Justification statement for change in layout

Staffin Harbour Reduced Breakwater Proposal Comparison Plan

Drg. No.	JG5462	Rev: 02	Date: 23.8.2024	Rev: 01	Date: 9.5.2024	Drawn	JG	Chk'd	MH
----------	--------	---------	-----------------	---------	----------------	-------	----	-------	----

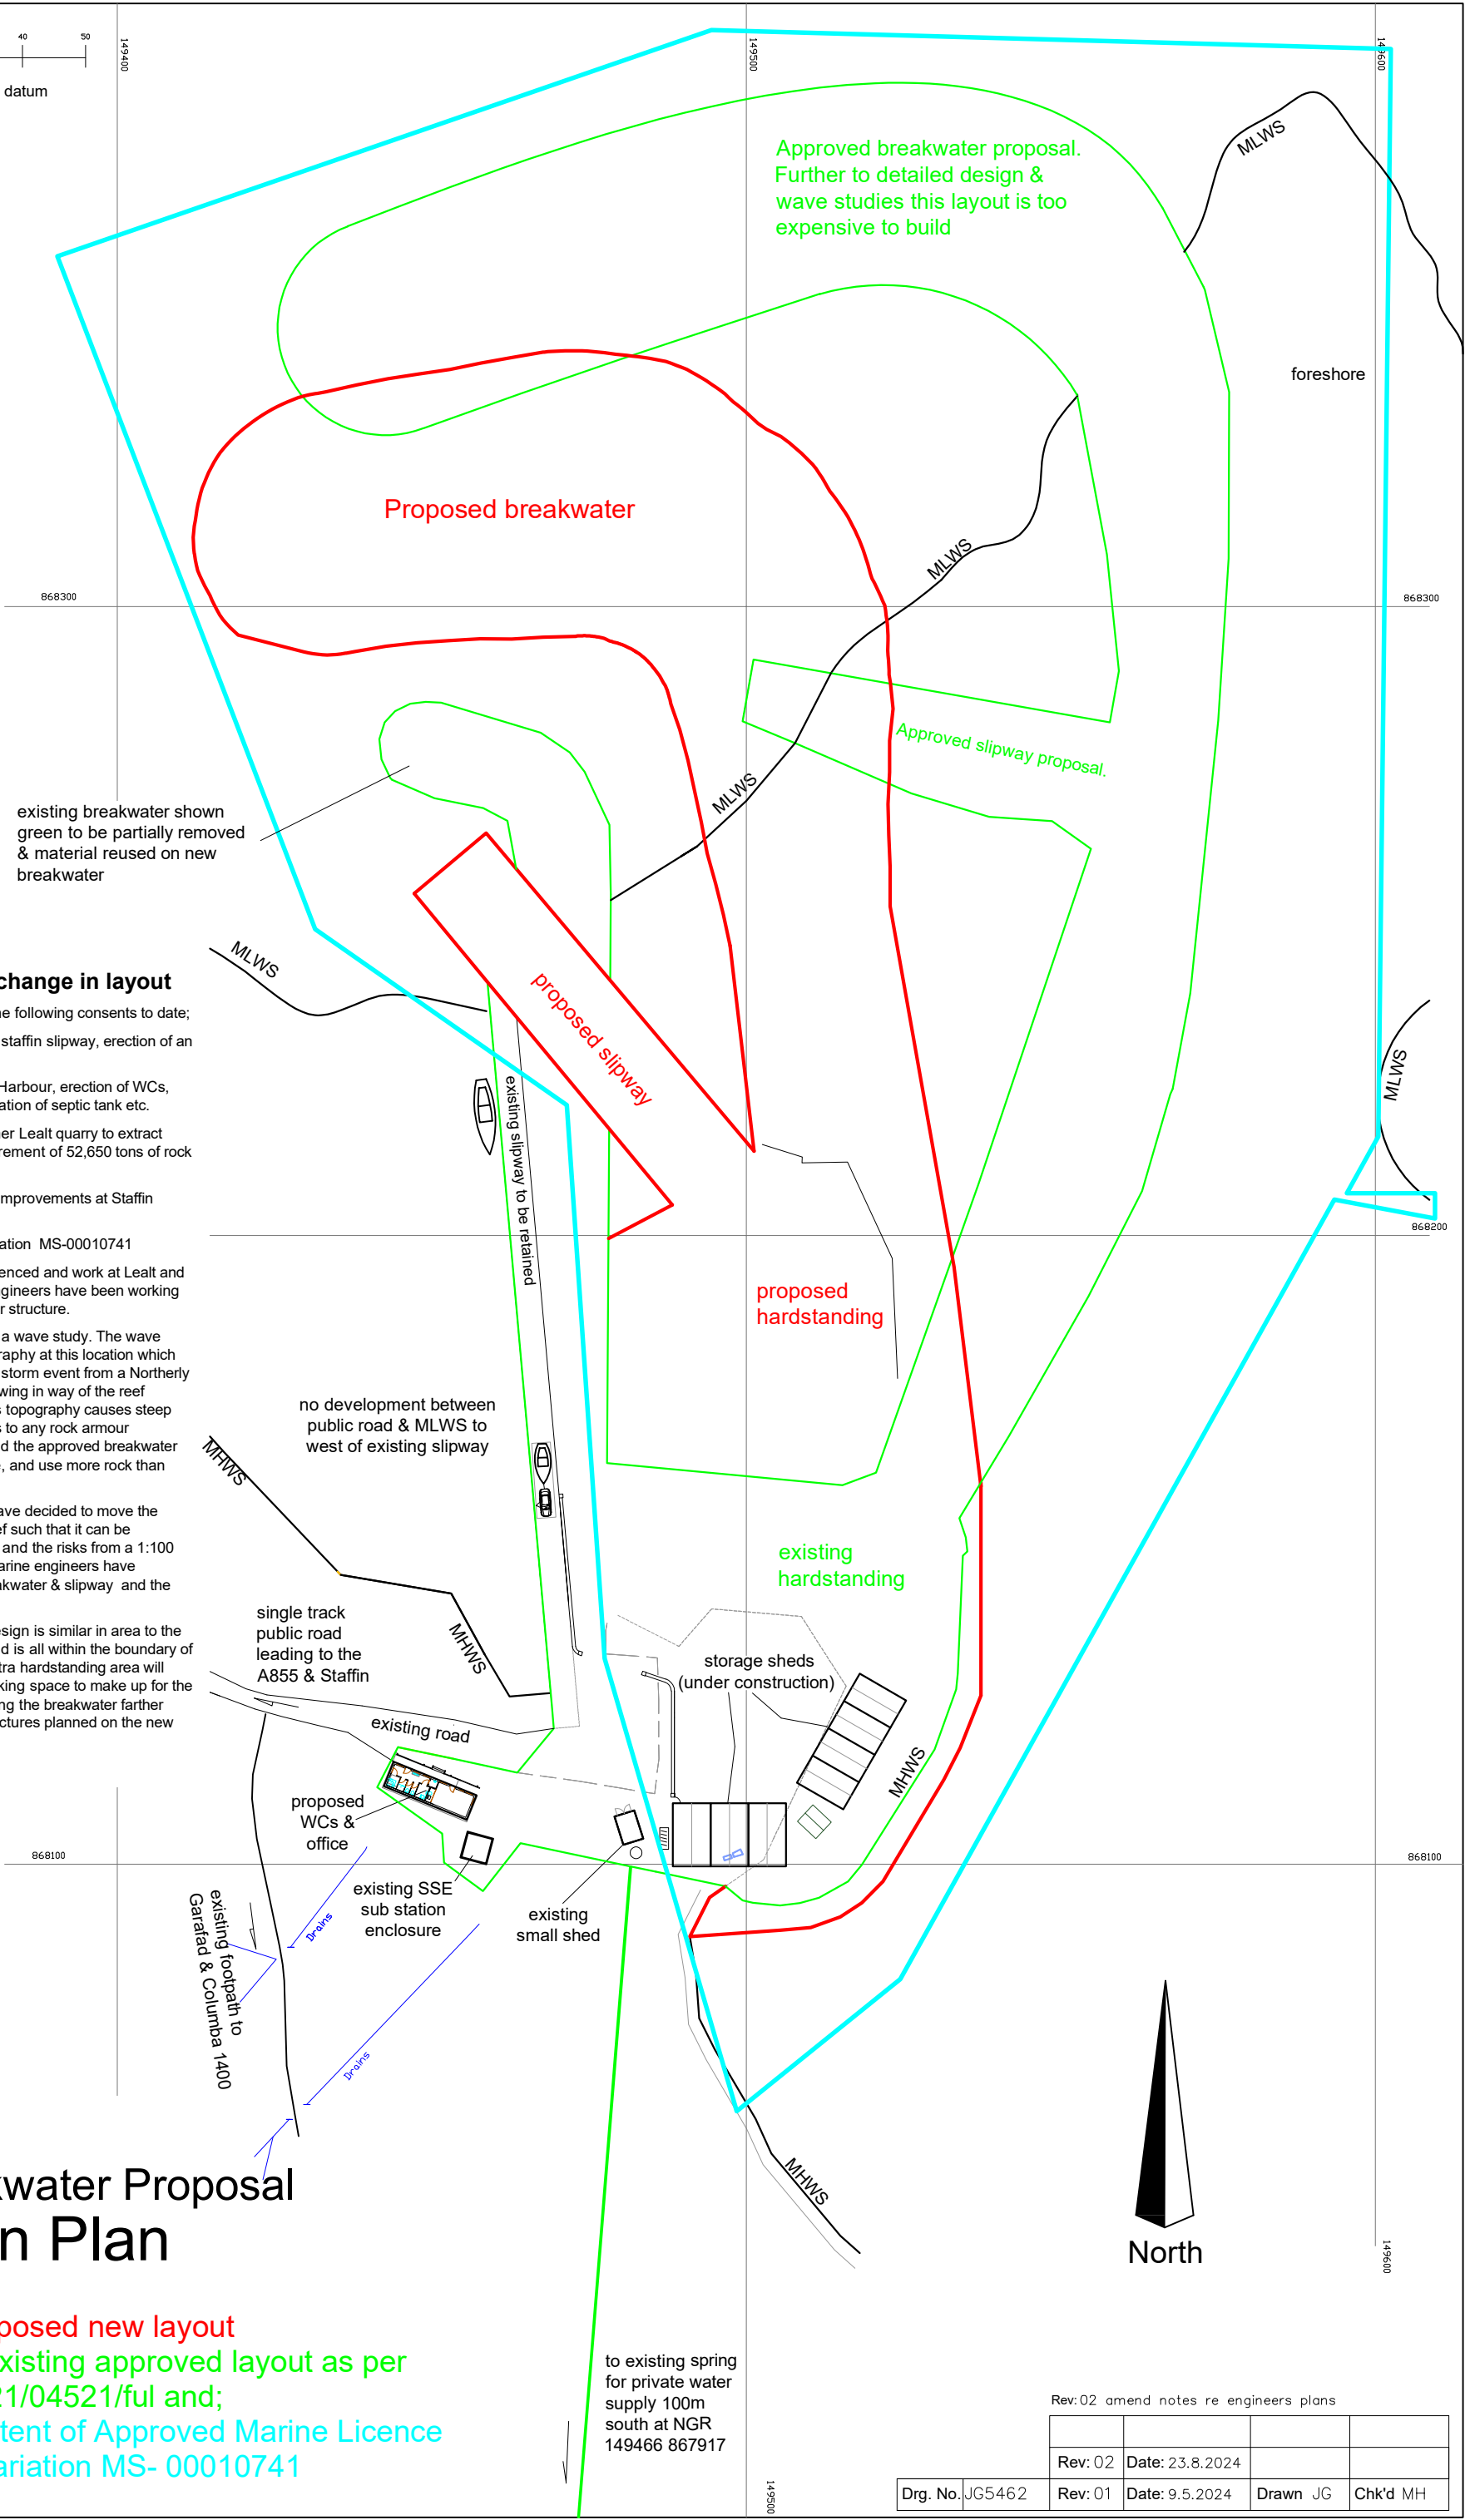
Part of the detailed design process includes a wave study. The wave study highlighted the unusual seabed topography at this location which presents unacceptable risks in a 1:100 year storm event from a Northerly direction, i.e. very deep water quickly shallowing in way of the reef between Staffin Island and the harbour. This topography causes steep breaking waves that are particularly onerous to any rock armour structures built near the reef. As such to build the approved breakwater (green line) would cost more than is feasible, and use more rock than Lealt borrow pit could provide.

Therefore the project team and engineers have decided to move the breakwater west & farther away from the reef such that it can be designed & built using the Lealt rock source and the risks from a 1:100 year Northerly storm are acceptable. The marine engineers have developed a detailed design of the new breakwater & slipway and the new hardstanding area.

The overall footprint & volume of the new design is similar in area to the footprint & volume of the previous design and is all within the boundary of the approved Marine Licence & EIA. The extra hardstanding area will provide more onshore boat, trailer & car parking space to make up for the reduction in pontoon berths caused by moving the breakwater farther inshore. There are no buildings or other structures planned on the new hardstanding area.

Red line indicates proposed new layout

Green line indicates existing approved layout as per planning consent ref 21/04521/ful and;
